<b>DEVELOPMENT NO.:</b>	22004073
<b>APPLICANT:</b>	DESYN HOMES
<b>ADDRESS:</b>	10 JEANES AV GLENELG NORTH SA 5045
<b>NATURE OF DEVELOPMENT:</b>	Internal alterations to existing single storey detached dwelling and two storey addition, carport and verandah
<b>ZONING INFORMATION:</b>	<p><b>Zones:</b></p> <ul style="list-style-type: none"> <li>• Established Neighbourhood</li> </ul> <p><b>Overlays:</b></p> <ul style="list-style-type: none"> <li>• Aircraft Noise Exposure</li> <li>• Airport Building Heights (Regulated)</li> <li>• Affordable Housing</li> <li>• Building Near Airfields</li> <li>• Character Area</li> <li>• Hazards (Flooding - General)</li> <li>• Prescribed Wells Area</li> <li>• Regulated and Significant Tree</li> <li>• Stormwater Management</li> <li>• Urban Tree Canopy</li> </ul> <p><b>Technical Numeric Variations (TNVs):</b></p> <ul style="list-style-type: none"> <li>• Minimum Frontage</li> <li>• Minimum Site Area</li> <li>• Maximum Building Height (Levels)</li> </ul>

<b>LODGEMENT DATE:</b>	15 Feb 2022
<b>RELEVANT AUTHORITY:</b>	Assessment Panel at City of Holdfast Bay
<b>CATEGORY OF DEVELOPMENT:</b>	Code Assessed - Performance Assessed
<b>NOTIFICATION:</b>	Yes
<b>RECOMMEND

*Southern side view of the development demonstrating the distance the upper level is set behind the main face*

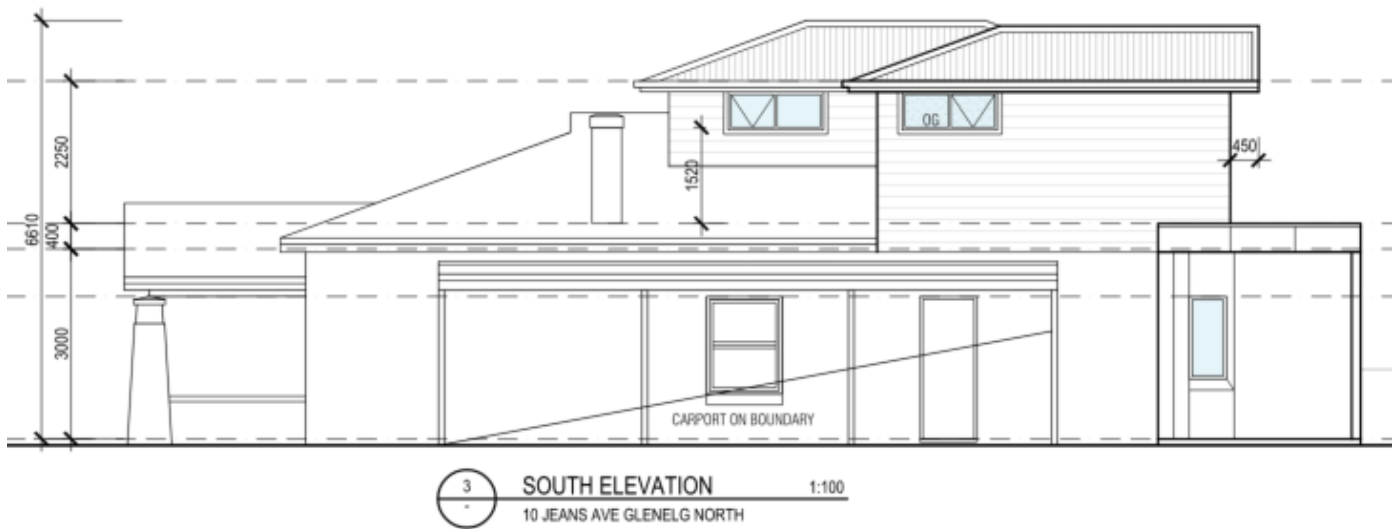
The proposal comprises an upper level addition to an existing single storey dwelling. The dwelling continues to present as single storey when viewed from the streetscape, as the upper level is setback 8.6 metres from the front of the existing building, which minimises the visibility of the addition.

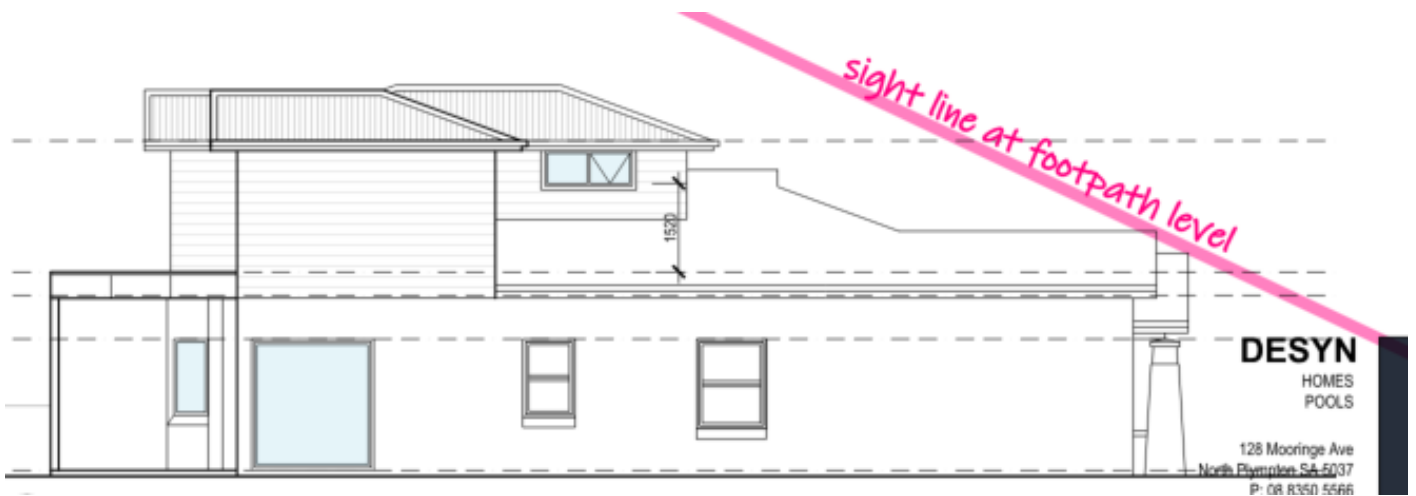
The upper level addition incorporates a design, materials and colours that match the existing dwelling. Although the 2-Dimensional front elevation, below, depicts a substantial looking building, the actual scale of the upper level is significantly limited when viewing the building from the footpath level and taking into consideration the distance the upper level is setback from the existing building façade. It is also noted that the front upper level walls are less than that of a typical two storey building. In effect, when viewing the building from street level, the existing façade will remain as the dominant visual element.

The addition is set back behind the front wall of the existing dwelling and incorporates an overall form that matches the existing bungalow. This includes a matching roof pitch and corrugated roof (the existing concrete roof tiles on the dwelling are going to be replaced with corrugated sheeting), weatherboard cladding (which is found in some instances throughout the locality) and painted battens to the roof fascia. A condition of planning consent is included to ensure that the roof, wall and fascias are painted to match the existing dwelling, which is red roofing and off-white walls and fascias (as confirmed by the applicant).

The addition maintains the high solid to void ratio and overall architectural theme of the existing dwelling, which is characteristic of the locality.

3. The roof, wall and fascias shall be painted to match the existing dwelling, which is red roofing and off-white walls and fascias.
4. That landscaping as detailed in the approved plans shall be planted within 12 months of completion and shall be maintained in good health and condition at all times. Any such vegetation shall be replaced if and when it dies or becomes seriously diseased.

***Northern side elevation of proposed addition demonstrating the sight line at footpath level***

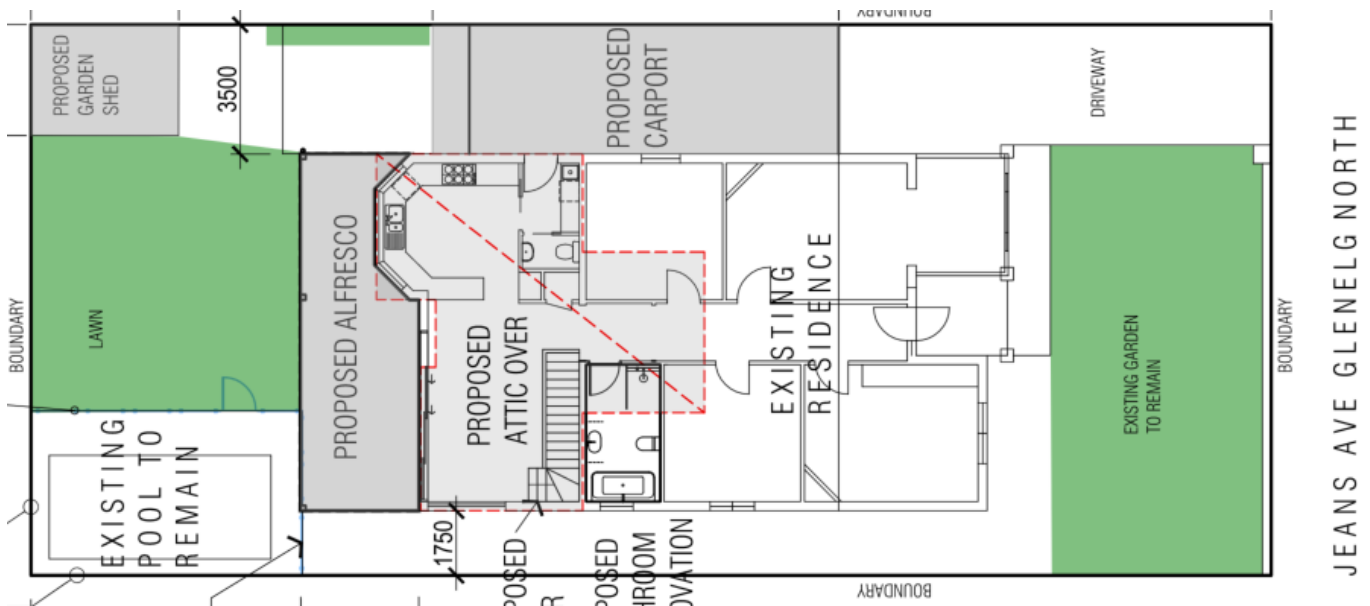
The Established Neighbourhood Zone references a maximum building height of 1 level. The building has been designed in such a way that the upper level is partially contained within the roof space, however in terms of its siting, it is more than 8 metres behind the main face of the single storey façade, the external wall height is only 5.5 metres high at the highest point, which is less than a conventional two storey dwelling. Critically, the upper level is not a key visual element as viewed from the footpath, as it is largely obstructed by the existing front roof.

*buildings that contribute to the prevailing character of the neighbourhood and complements the height of nearby buildings. The proposed building is considered to satisfy the fundamental objective of PO 4.1.*
